related to operation of
NINE MILE POINT NUCLEAR STATION
UNIT 1

DOCKET NO. 50-220

JANUARY 1974

REGULATORY DOCKET FILE COPY
UNITED STATES ATOMIC ENERGY COMMISSION
DIRECTORATE OF LICENSING

Fig. 2.6. Average Monthly Temperature of Lake Ontario.

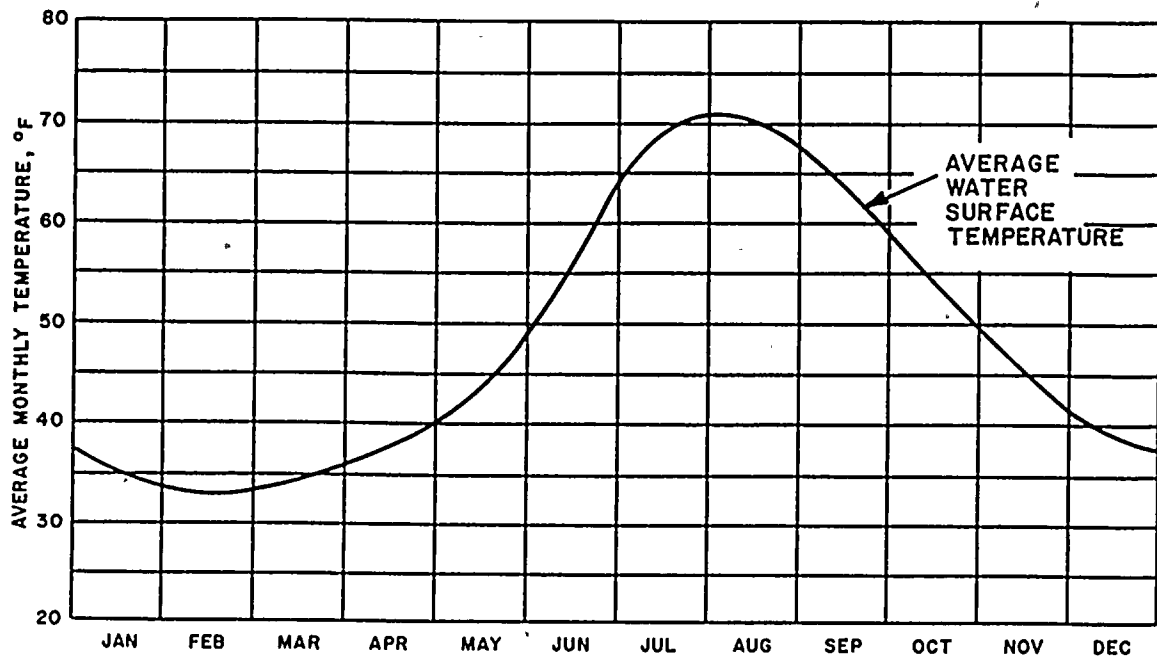
Paragraph 3 and Figure 2.6 note that Lake Ontario has a maximum surface temperature of 72°F during summer. Paragraph 2 of Section 3.4 (Page 3-7) states that the intake water temperature varies with the season from 33 to 77°F. Initial impact implies a discrepancy (this impact is further substantiated by statements that vertical thermal stratification exists during the summer, and that the intake structure is a minimum of 15 feet below the surface), unless it is clarified (as in the FitzPatrick Environmental Technical Specifications) that: (1) the 77°F temperature is the maximum recorded Lake temperature, and (2) that 77°F is the conservative design basis for establishing the maximum allowable discharge temperature.

Paragraph 3 and Figure 2.6 note that Lake Ontario has a maximum surface temperature of 72°F during summer. Paragraph 2 of Section 3.4 (Page 3-7) states that the intake water temperature varies with the season from 33 to 77°F. Initial impact implies a discrepancy (this impact is further substantiated by statements that vertical thermal stratification exists during the summer, and that the intake structure is a minimum of 15 feet below the surface) unless it is clarified (as in the FitzPatrick Environmental Technical Specifications) that: (1) the 77°F temperature is the maximum recorded Lake temperature, and (2) that 77°F is the conservative design basis for establishing the maximum allowable discharge temperature.

The temperature plotted in Figure 2.6 of the Draft Statement are the values for a given day of the year, averaged over the years of record through 1971. The resultant curve has a maximum point early in August, with a value of 72°F. However, this value is itself the average of a recorded range not an actual maximum.

Fig. 3.2. Nine Mile Point Unit 1.

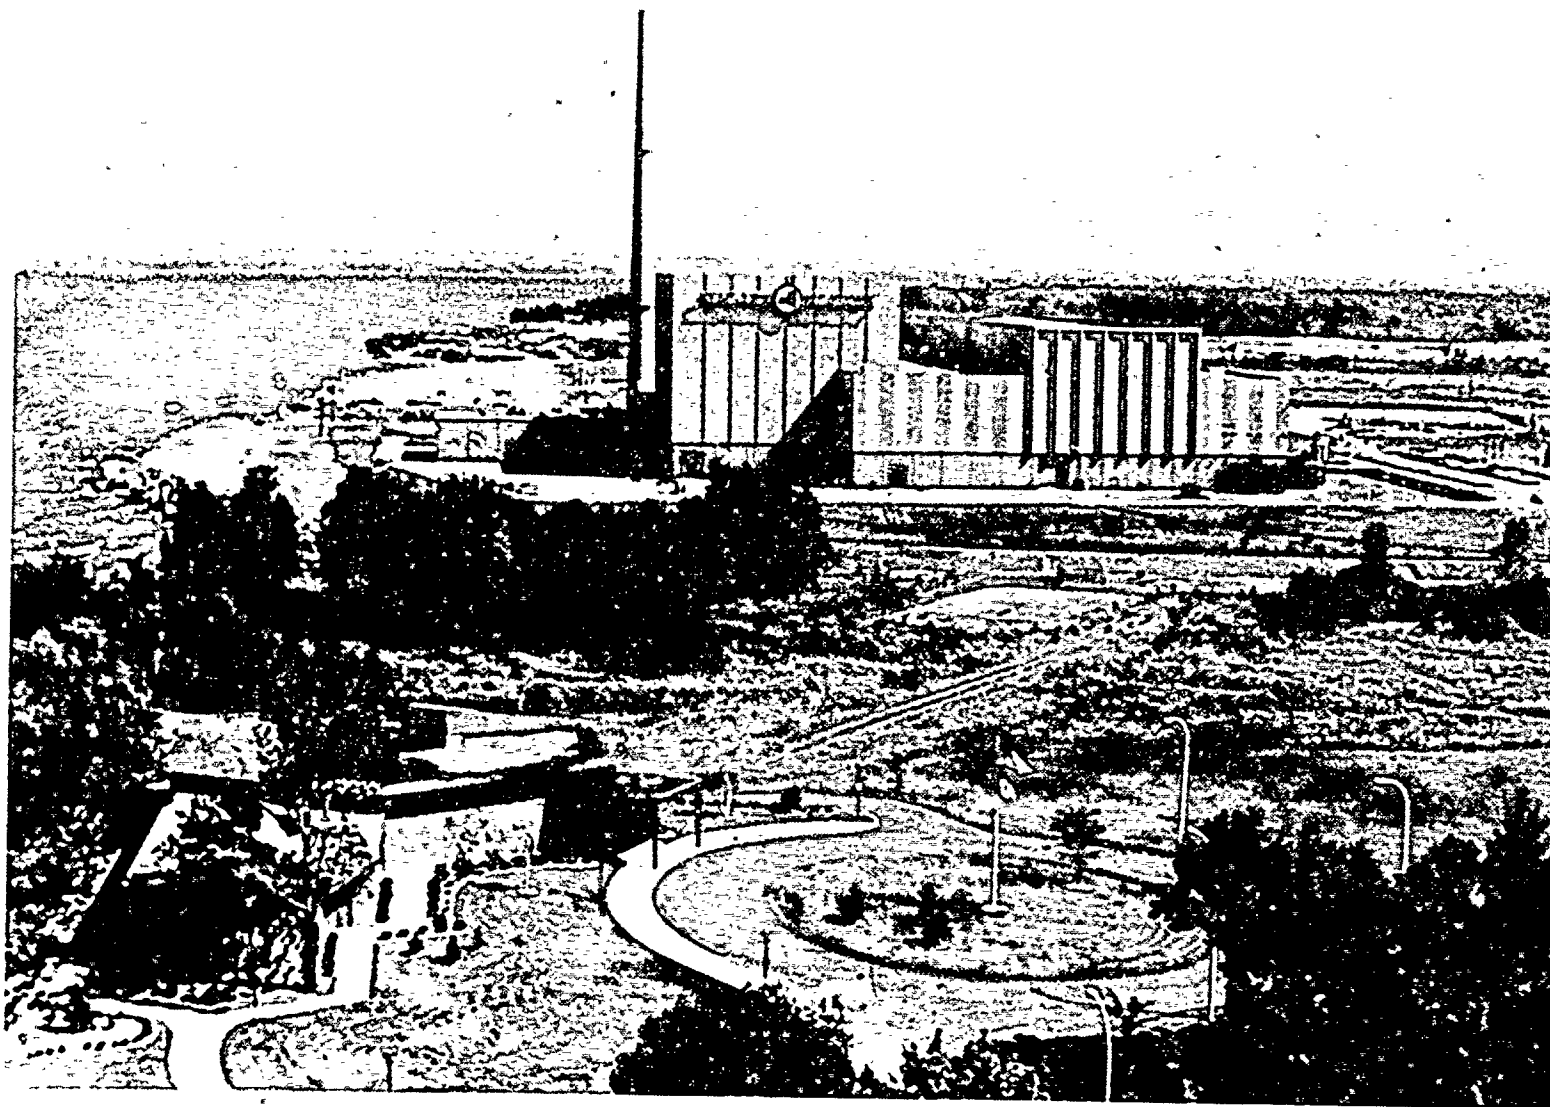
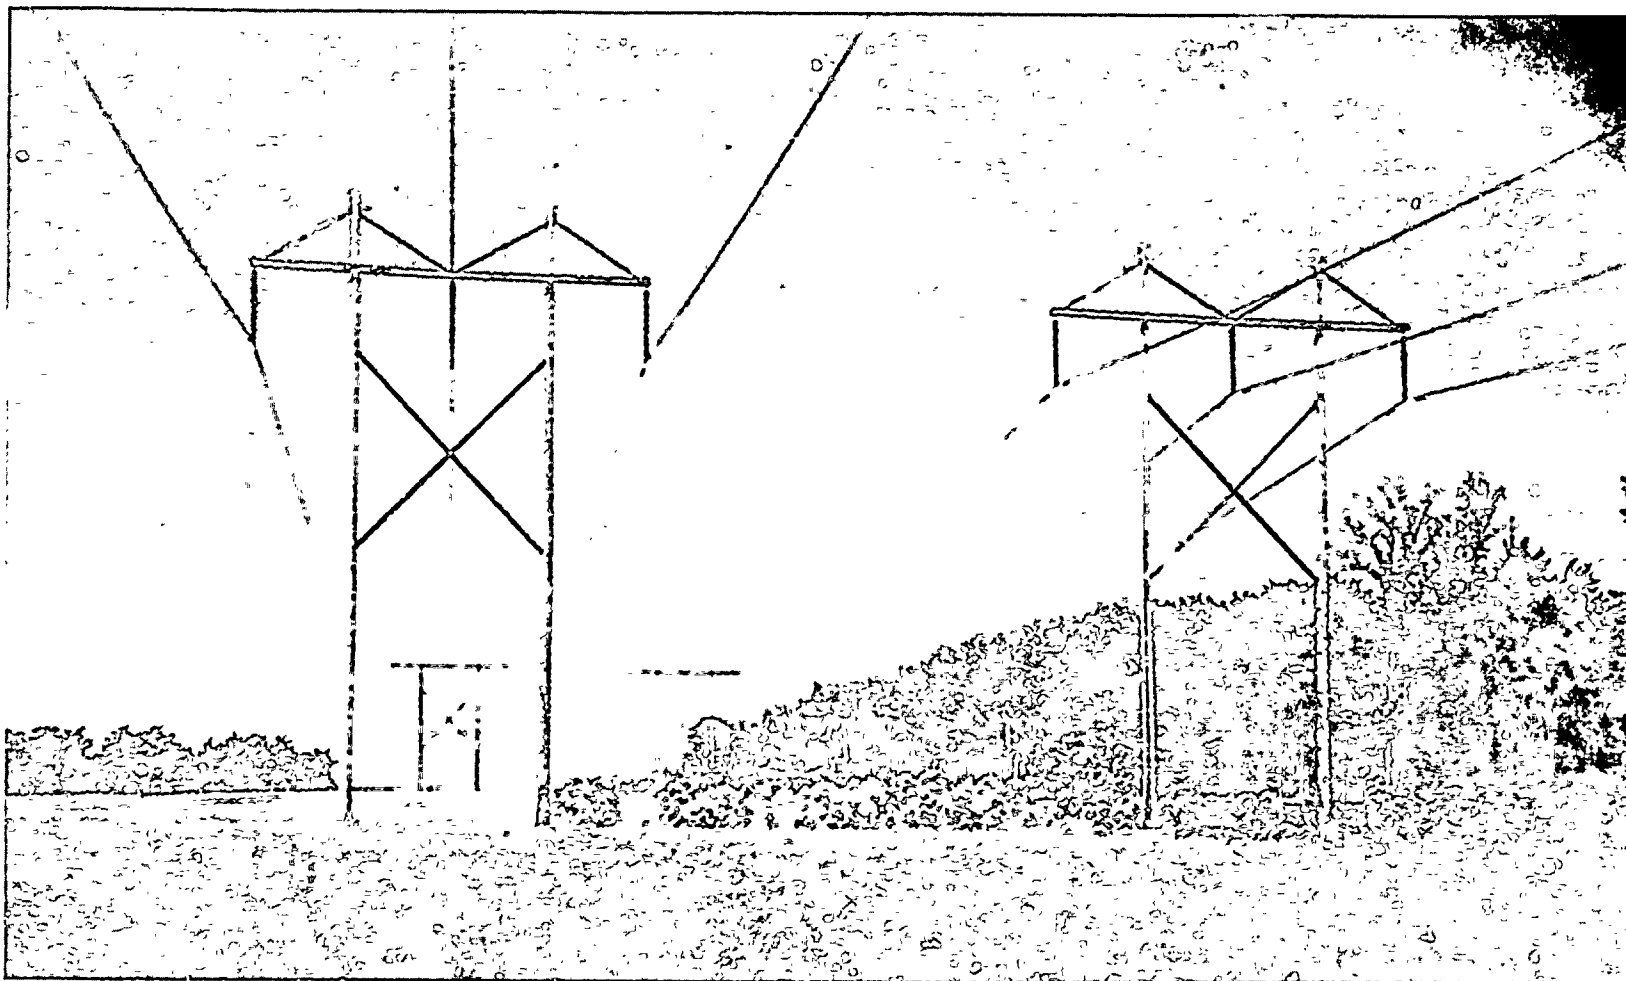
- d. Figure 2.5, Page 2-9; Figure 3.2, Page 3-3, and Figure 3.14, Page 3-38
The poor quality of the photographs in Figures 2.5, 3.2 and 3.14 does little to promote the aesthetic features of the facility.

Fig. 3.4. Intake and Discharge Structure Locations: Plan.

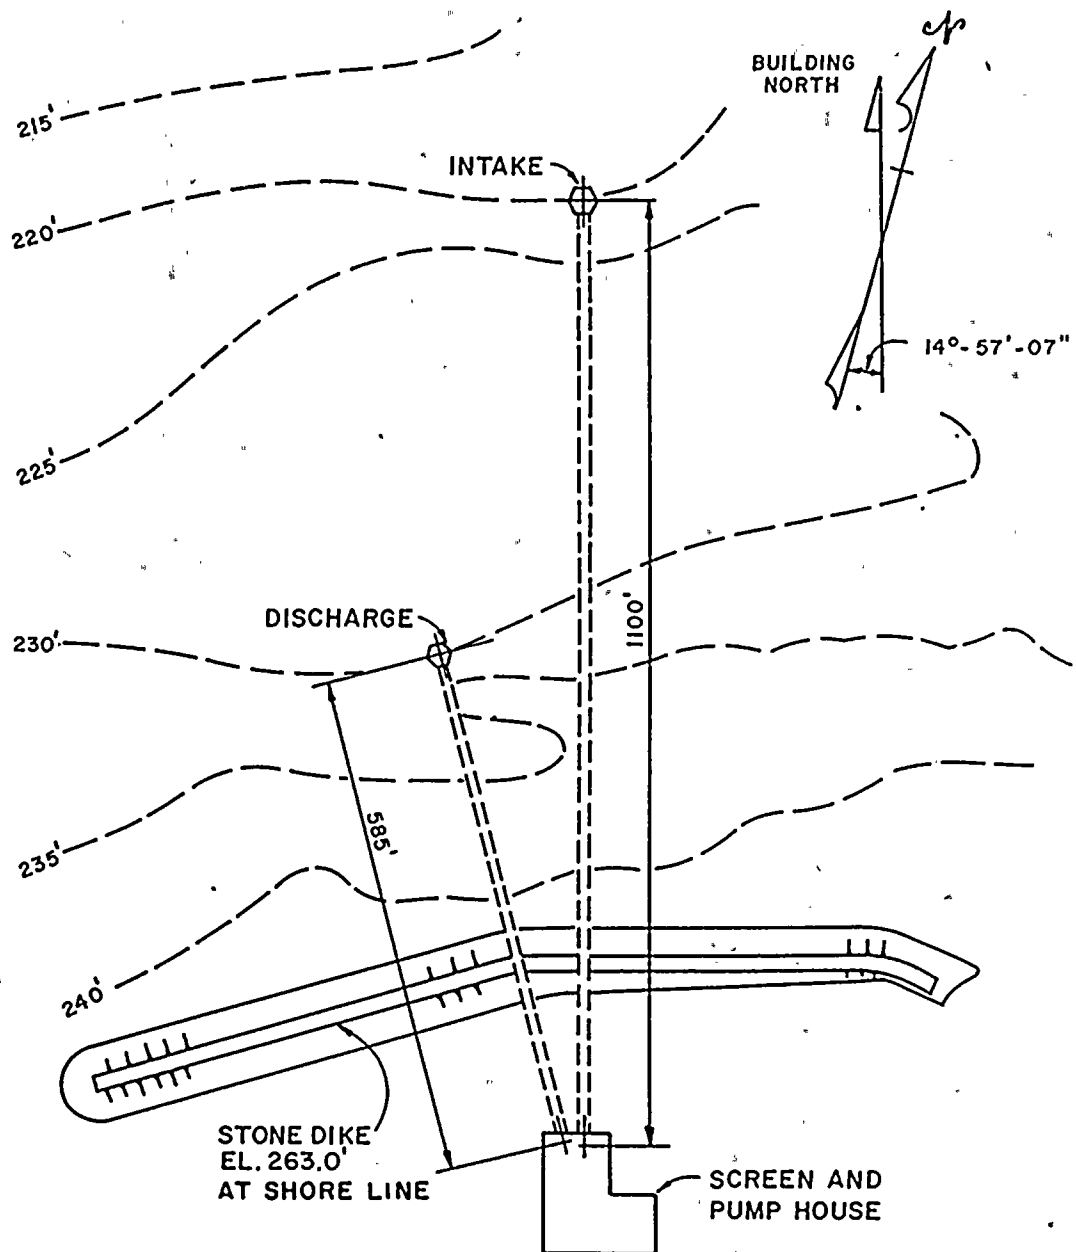
Figure 3.4 is entitled "Circulating Water System: Plan."

It is recommended that this title be modified to "Intake and discharge structure locations: Plan." This title more correctly describes that portion of the cooling water system depicted, and is consistent with the description contained in Section 3.4. In addition, for clarity (Reference Figure 3.4 of FitzPatrick's Final Environmental Statement dated March, 1973) the intake and discharge tunnels should be labeled, and after "intake" and "discharge" the word "structure" added.

Figure 3.4 is entitled "Circulating Water System: Plan." It is recommended that this title be modified to "Intake and discharge structure locations: Plan." This title more correctly describes that portion of the cooling water system depicted, and is consistent with the description contained in Section 3.4. In addition, for clarity (Reference Figure 3.4 of FitzPatrick's Final Environmental Statement dated March, 1973) the intake and discharge tunnels should be labeled, and after "intake" and "discharge" the word "structure" added.

Fig. 3.6. Diagrammatic Sketch of the Screenwell.

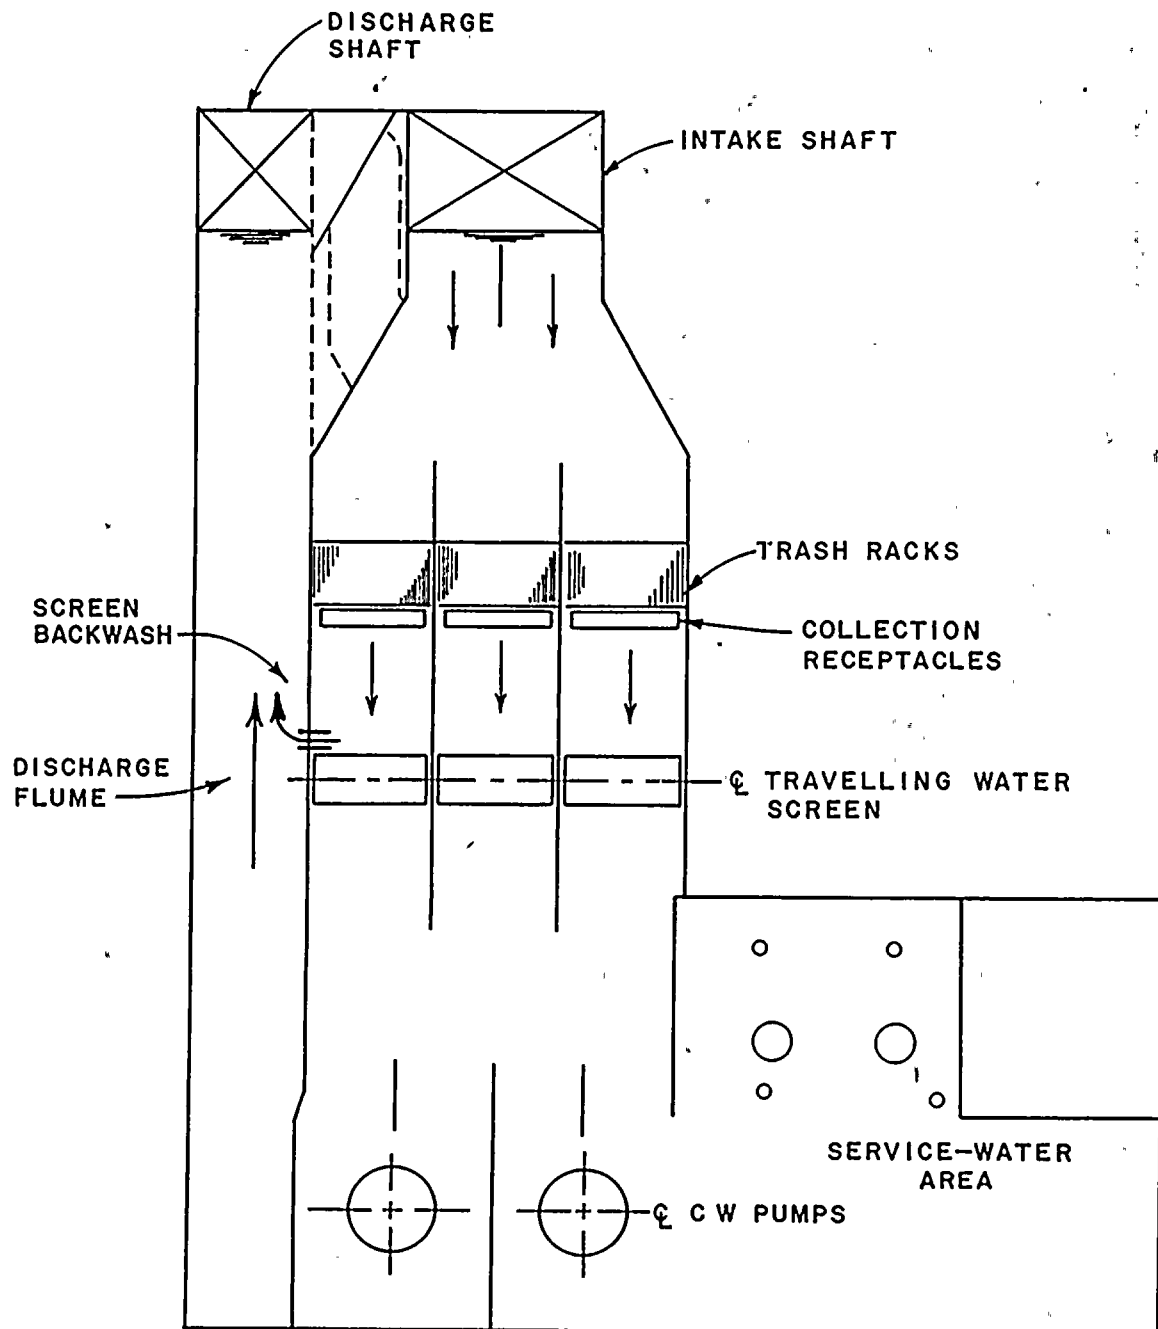
than "Schematic Diagram." Schematic Diagram intonates single line (wiring, piping, etc.) depictions. The title of Figure 3.6 should also be changed.

The service water and fire pumps should be labeled on Figure 3.6, since paragraph 3.4.1 refers to them as being shown of Figure 3.6

The service water and fire pumps should be labeled on Figure 3.6, since paragraphs 3.4.1 refers to them as being shown on Figure 3.6.
